Permit Type	Permit Number	Opened Date
Building/Residential/Misc/Pool Spa	B19001327	05/06/2019
Description of Work		
SFD, 38'X20' IN GROUND CONCRETE POOL, DEPTH 3'TO8', 6'FENCE TO CODE, FILLED BY TRUCK

Re: Brighton Mill, Phase 2, Lot 12
Sewage Disposal Area setback variance request

PROJECT:	BRIGHTON MILL II LOT 12	
LOCATION:	TAX MAP: 34, GRID: 2, PARCEL: 16 ZONED: RR-DEO 13602 CURTIS VISTA WAY CLARKSVILLE, MD 21029 FIFTH ELECTION DISTRICT, HOWARD COUNTY, MD, TAX ID #05-600593	
TITLE:	REVISED PERCOLATION CERTIFICATION PLAN	
HOUSE TYPE:	CLIFTON PARK - ELEVATION D	
DATE:	JUNE, 2019	PROJECT NO. 2627
SCALE:	AS SHOWN	DRAWING 1 OF 1

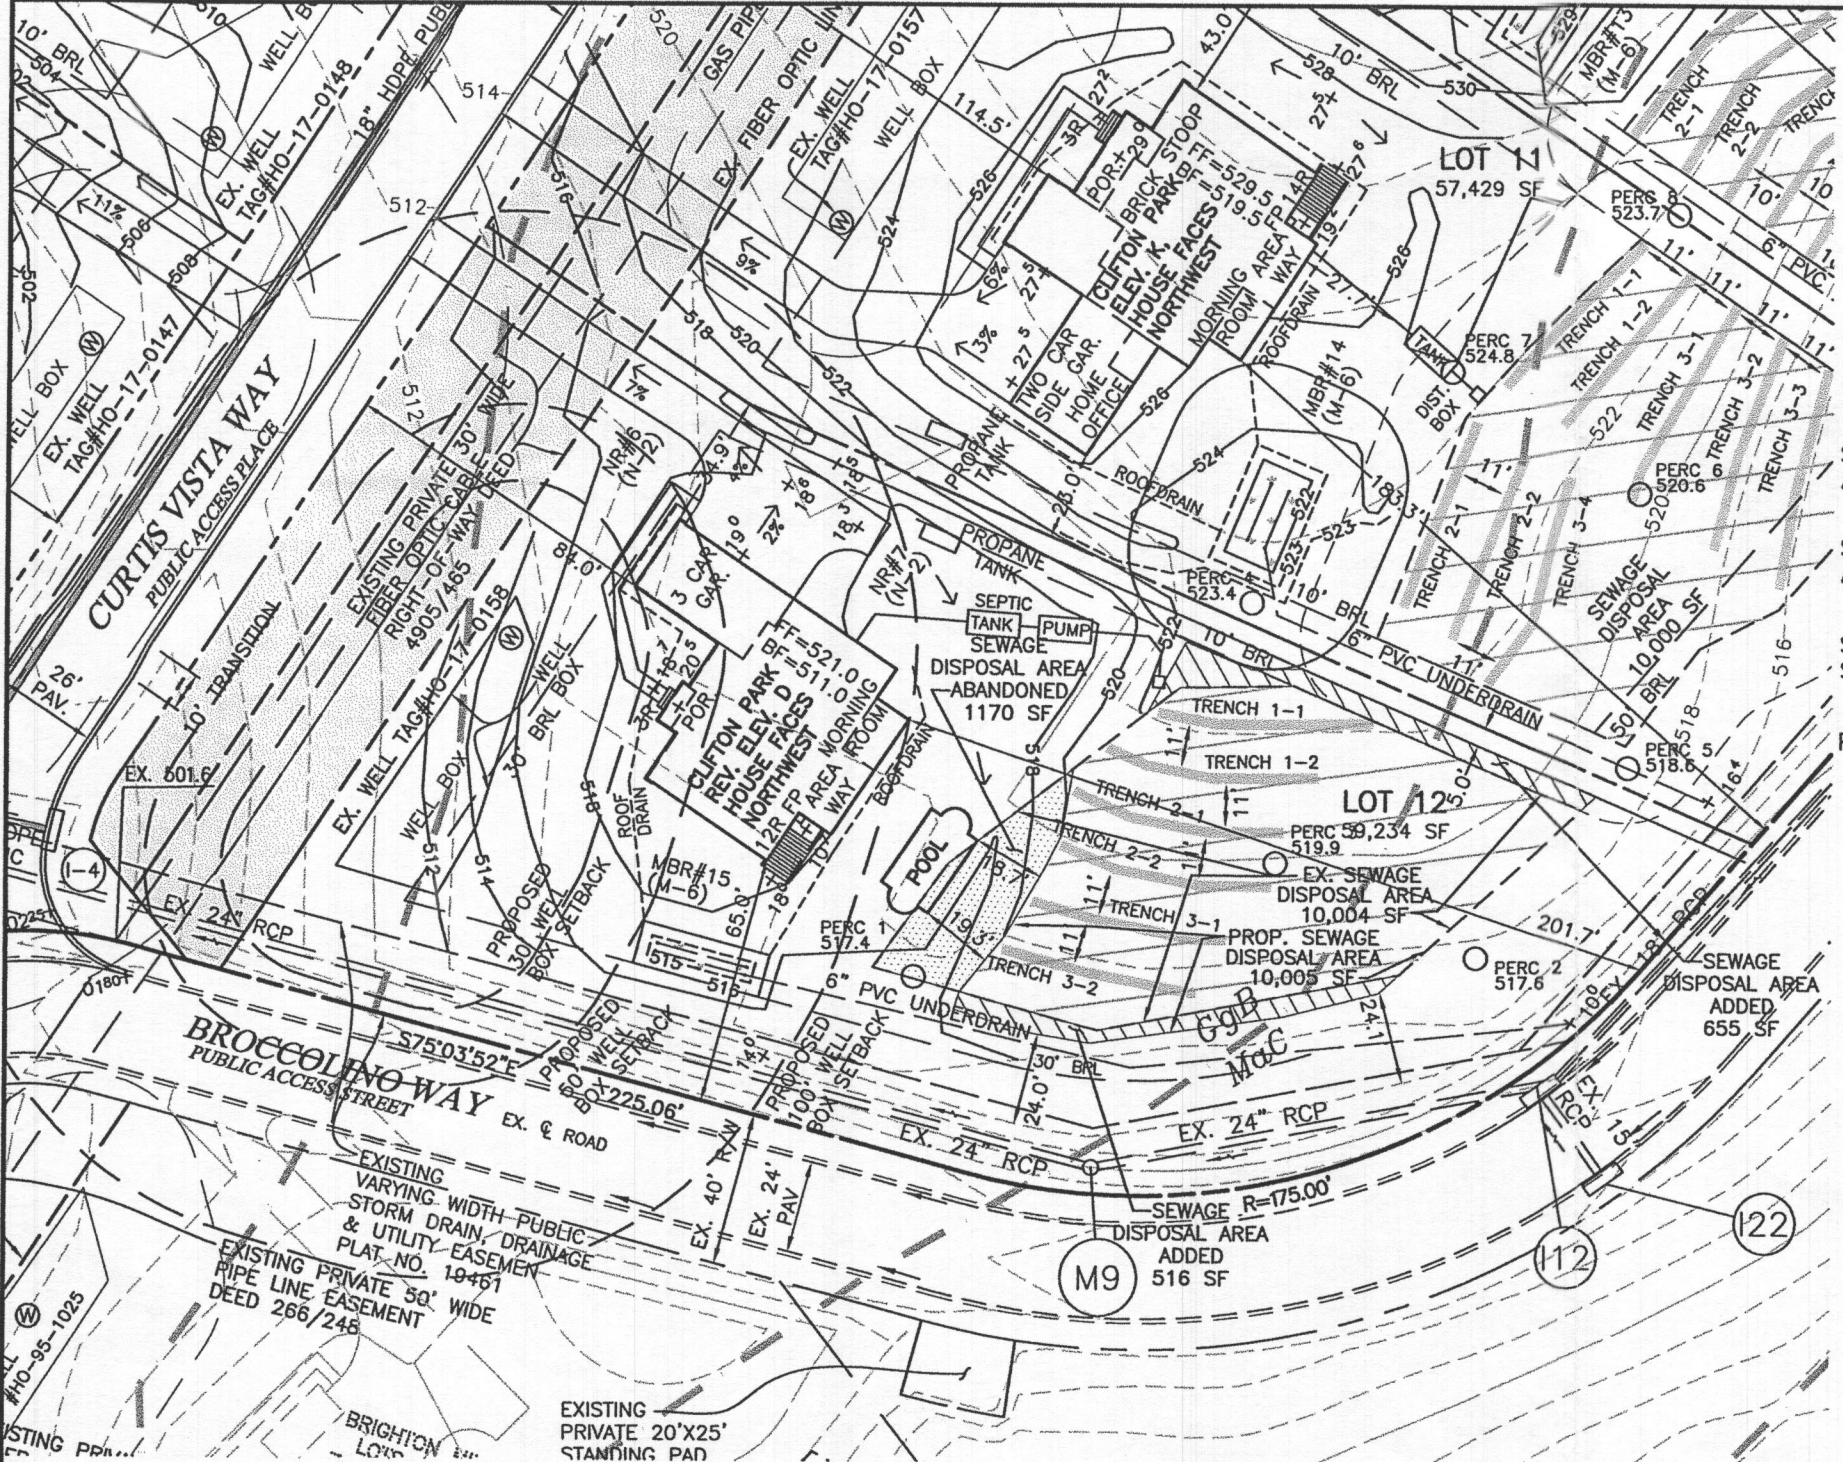
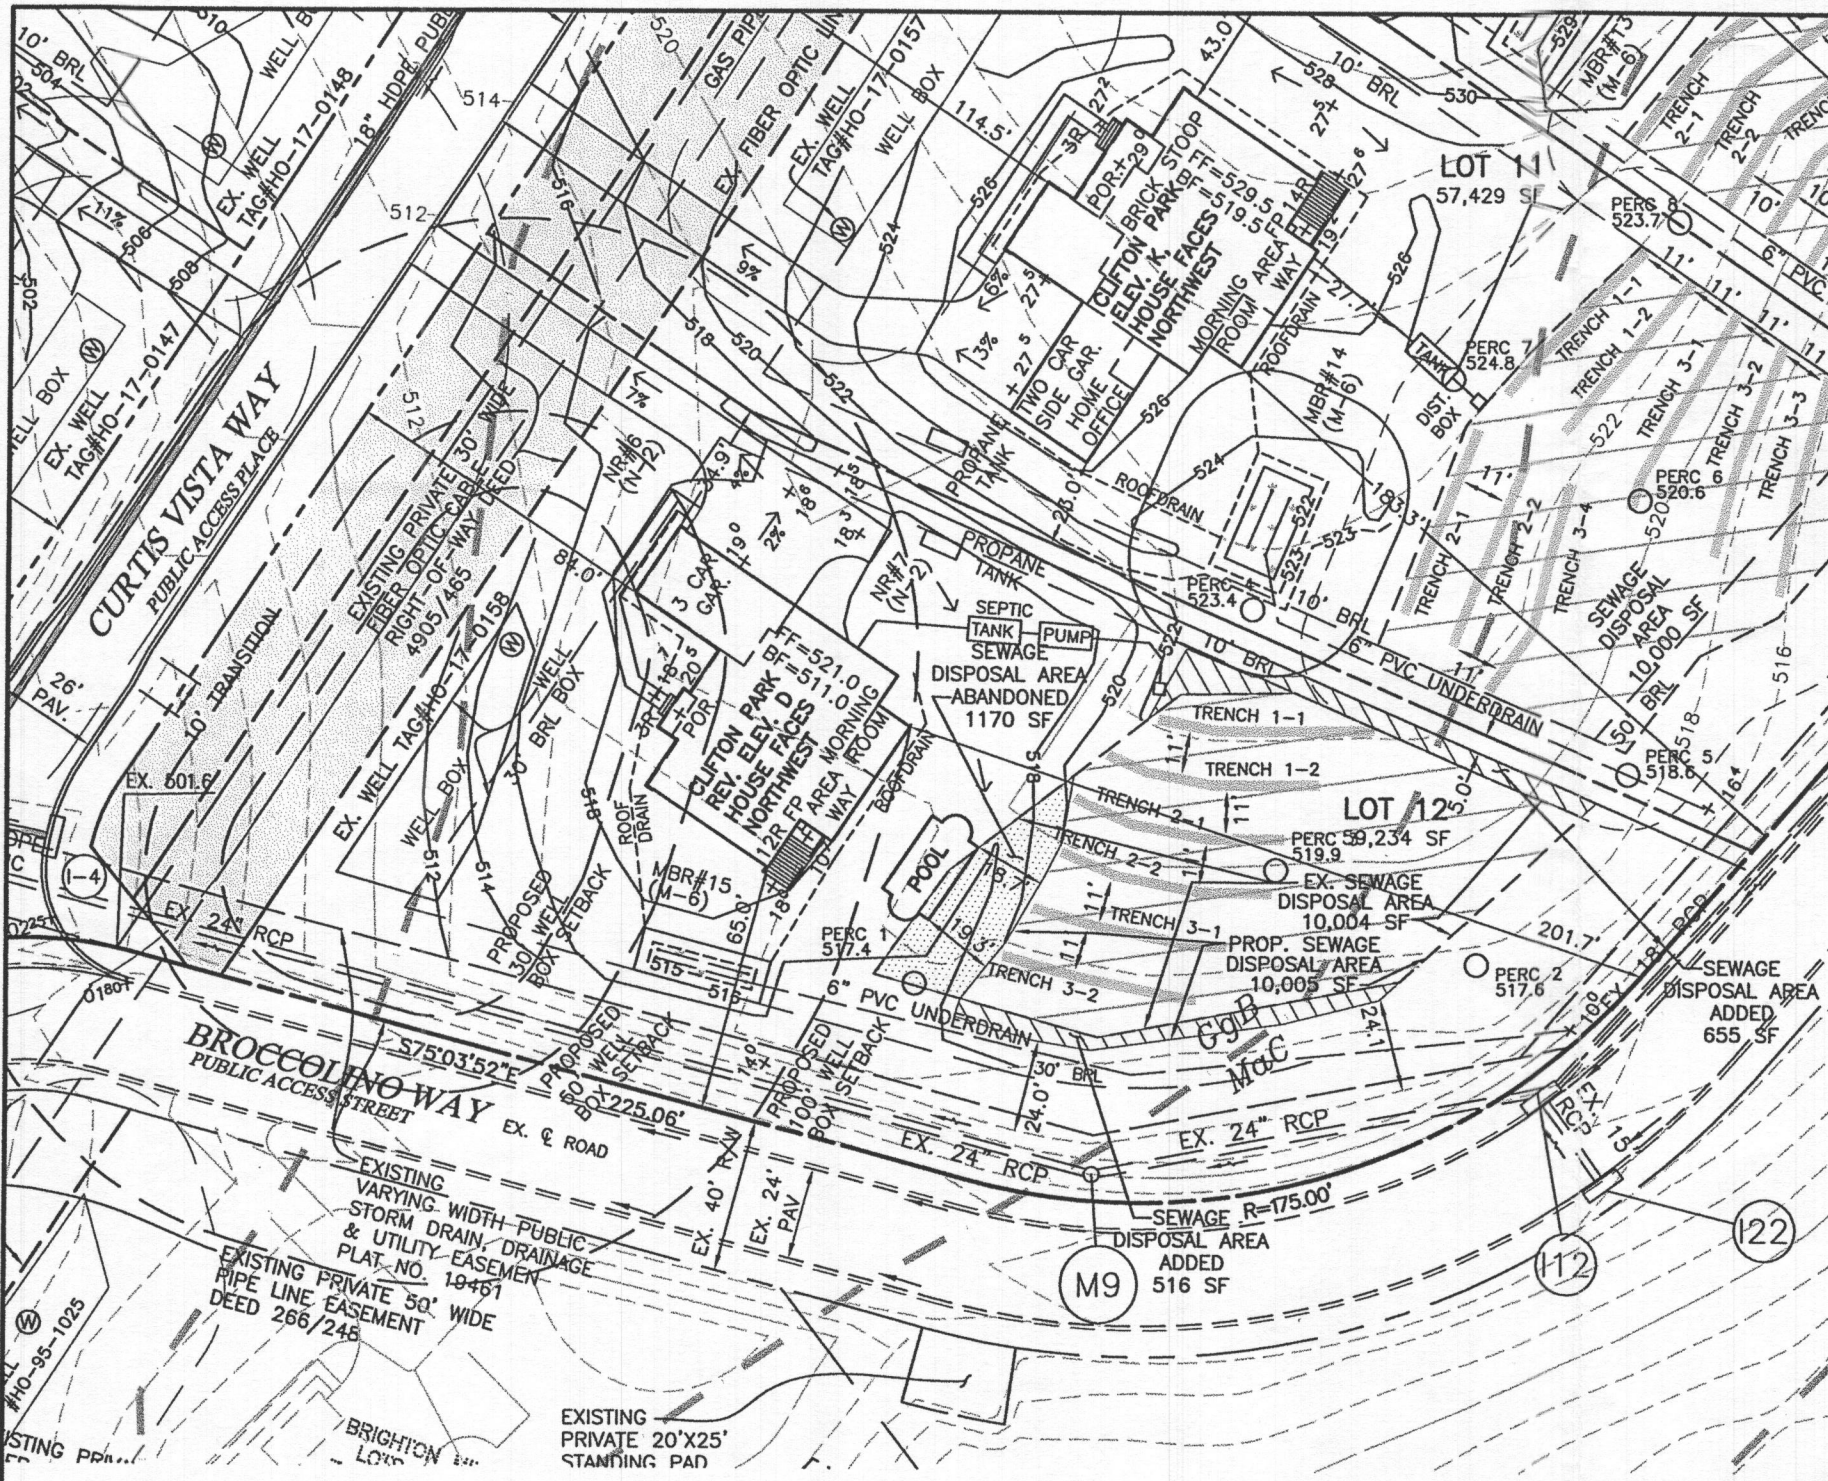
I am writing to request a variance from the Maryland Department of the Environment for the separation distance between my on-lot sewage disposal area and a proposed pool, the property line and steep slopes. The initial sewage disposal system has been installed and the Engineer has designed the two future repair systems as shown on the attached plan. The percolation test results revealed a design that is very compact due to an application rate of 1.2 and an effective sidewall of 3.5' to 4.0'. We plan on constructing the pool very soon and wish to modify the sewage disposal area to accommodate the pool design while still provide adequate future sewage disposal.

Regarding the setback from the sewage disposal area to the swimming pool, the design has maintained a minimum distance of 18.7', a reduction of 1.3' from the required 20' setback. This is the area necessary to grade around the pool without grading into the septic disposal area.

Regarding the setback from the sewage disposal area to the side property line, the design has maintained a minimum distance of 5.0', a reduction of 5.0' from the required 10' setback. The side property line is straight and could easily be surveyed in the future. The design of the future sewage disposal trenches shows a design that is not near this property line.

Regarding the setback from the sewage disposal area to the 25% or greater slopes, the design has maintained a minimum distance of 24.0', a reduction of 1.0' from the required 25' setback. This area is necessary to provide the full 10,000 sf of disposal area. It is likely that only one trench for the third repair system would fit within this area and only the very end of the trench would be within the area of the one foot reduction.

7/8/19
Approved
M J Dan

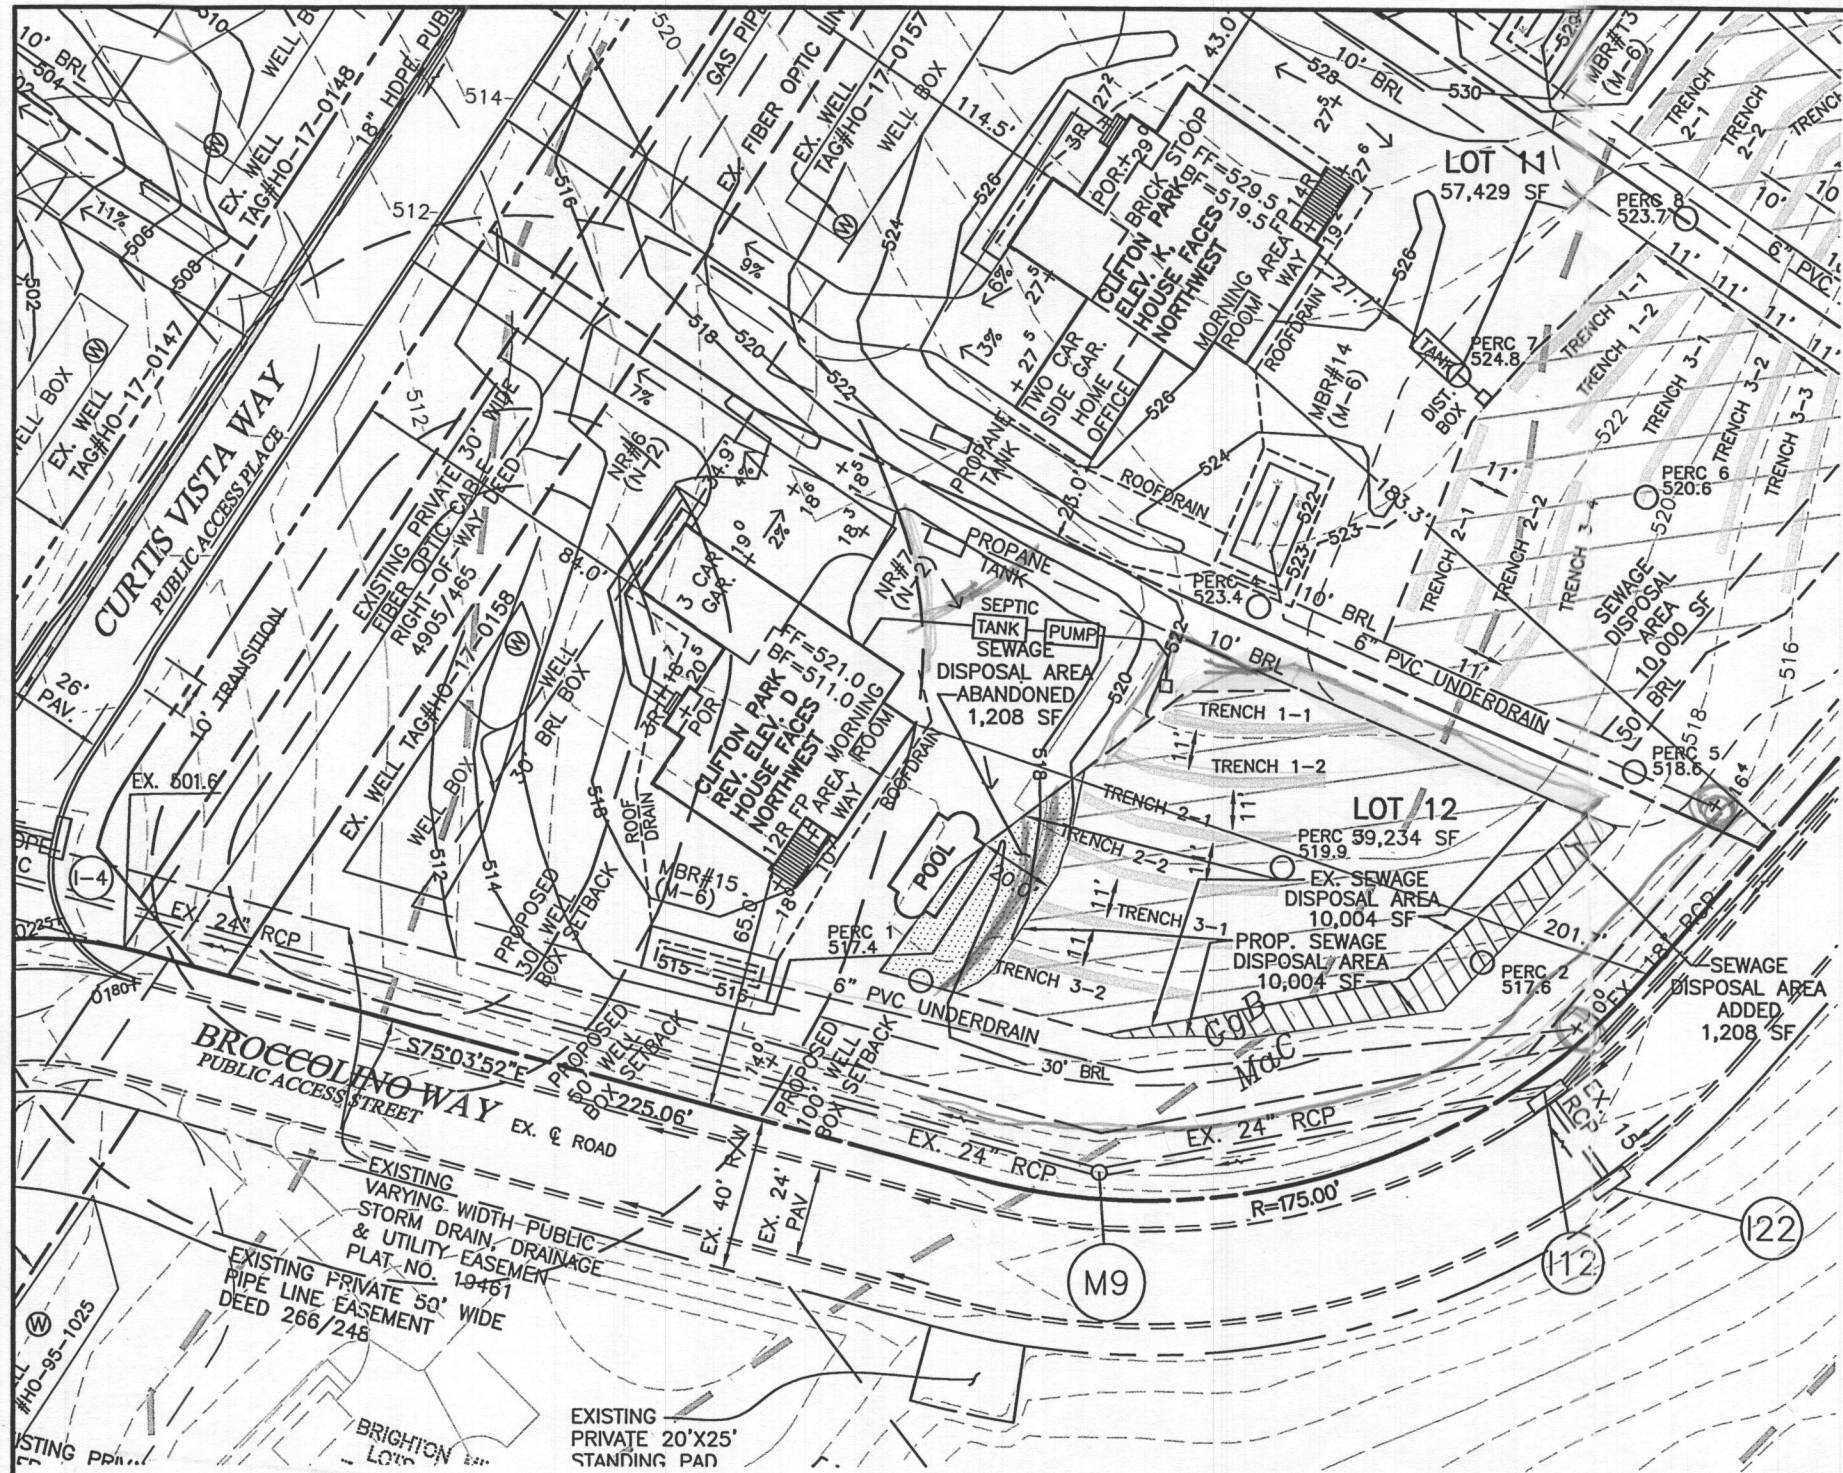
Good morning. After conducting a site visit and reviewing the Perc Cert Plan with Jeff, we would prefer to stay at least 25 feet from the graded hillside (See Pics Attached) and not add area at the bottom. Instead, we would be in favor of reducing the setback from 10 ft. to 5 ft. to the property line and add area on the north side of the sewage disposal area (See Attached Plan). Should you still need more area to obtain 10k sq. ft., you could ask for a waiver to the setback from 20 ft to 15 ft from a pool to the sewage disposal area.

Good morning. Please revise the perc cert to show the adjustments to the SDA and correct the legend symbols to match.

The perc cert plan for 13602 Curtis Vista Way has been approved. You may use a copy of the perc cert plan (See attached) as the revised building permit (BP) site plan but you will need to add the dirt stock pile and pool equipment locations to it. Once this has been done, please submit a copy to permits.
